**ITEM 8. DEVELOPMENT APPLICATION: 210-220 GEORGE STREET SYDNEY**

**FILE NO: D/2016/1675**

**Proposal Summary:** The proposal is for a Stage 1 development application seeking consent for a 25-storey building envelope. The indicative land uses are for commercial, retail and entertainment, with loading access from Underwood Street and indicative basement car parking with access from Dalley Street. The application was notified and advertised for 41 days (extended for the Christmas period) from 9 December 2015 to 19 January 2017. Two submissions were received, which raised concerns regarding:

Figure 8: Proposed building massing envelope

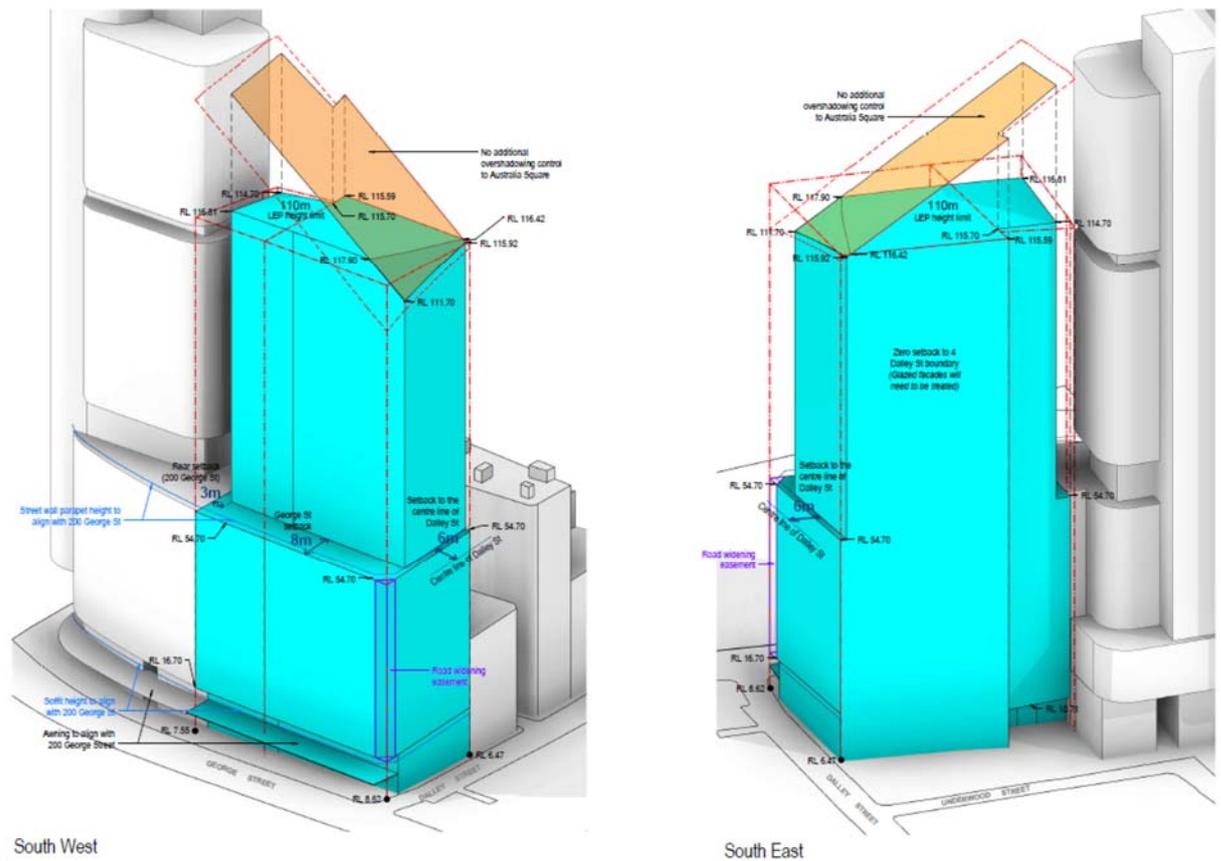
12. The Applicant originally submitted plans which showed the eastern portion of the proposed northern facade of the building for the 'typical tower levels' intruding into the setback easement for light and air to 200 George Street on the eastern façade. In addition, the proposal did not comply with flood levels. The plans were amended accordingly.
13. Drawings of the proposed Stage 1 DA building envelope for which consent is sought are included at **Attachment B**. The proposed building envelope is illustrated at **Figure 8** below.

Figure 11: Upper Ground Floor Plan

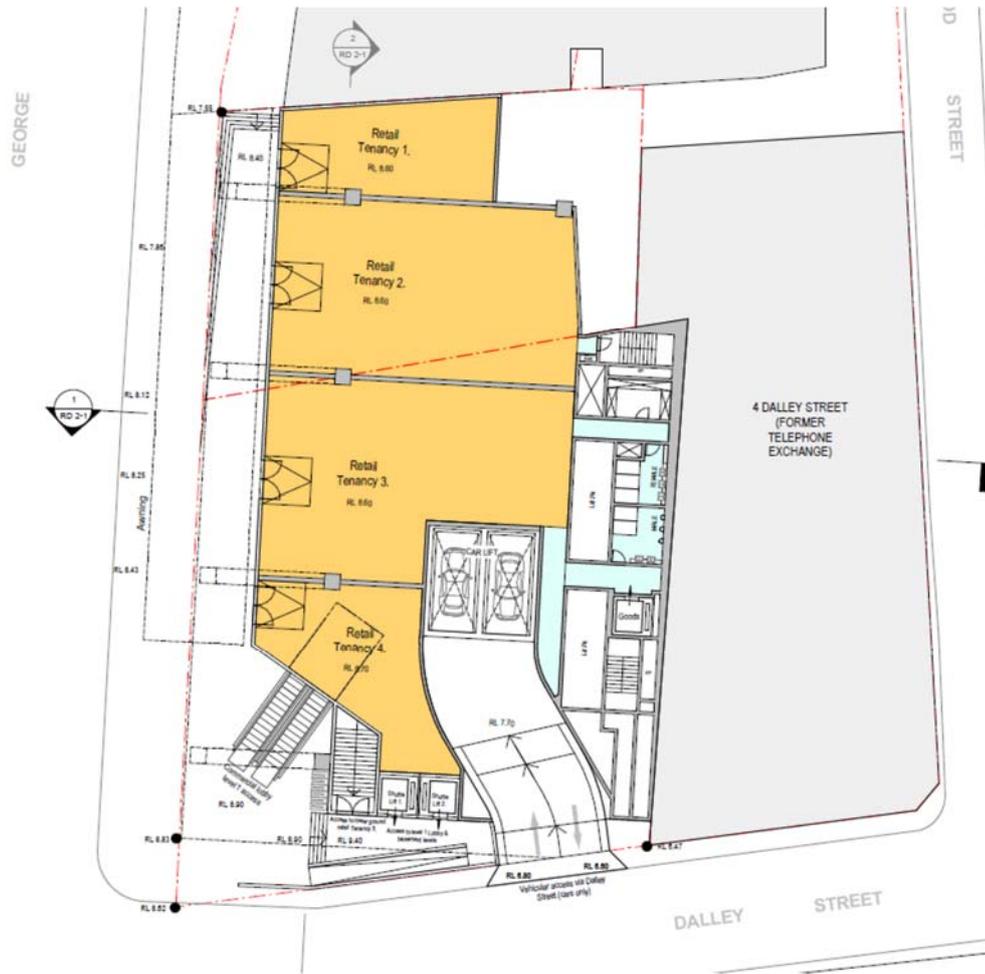
37. While the activation of the George Street frontage is supported and will provide finer grain retail, the treatment of the podium at the corner of Dalley and George Streets is to be further addressed within the design competition and the Stage 2 DA. The building form should more closely align to the street edges and should provide a more continual simplified alignment to the street corner instead of the multi-faceted approach indicated in the plans below.

38. The indicative plans also indicate external escalators leading to a level 1 commercial lobby. The applicant has stated that having the lobby at this level provides a number of benefits, including the possibility of a large terrace area which could be landscaped; provides additional public open space; increases the amount of active frontages available; and would provide a distinct entrance to the development.

39. In its current form, the lobby at level 1 is not supportable. The lobby should either be at footpath level or, the escalators should be contained wholly within the glass line of the building. External escalators are not supported.

40. The carpark entrance from Dalley Street is excessively wide with the steps from the podium forming an awkward juxtaposition with the driveway. This arrangement creates legibility issues for pedestrians and will therefore require further resolution in the Stage 2 DA.
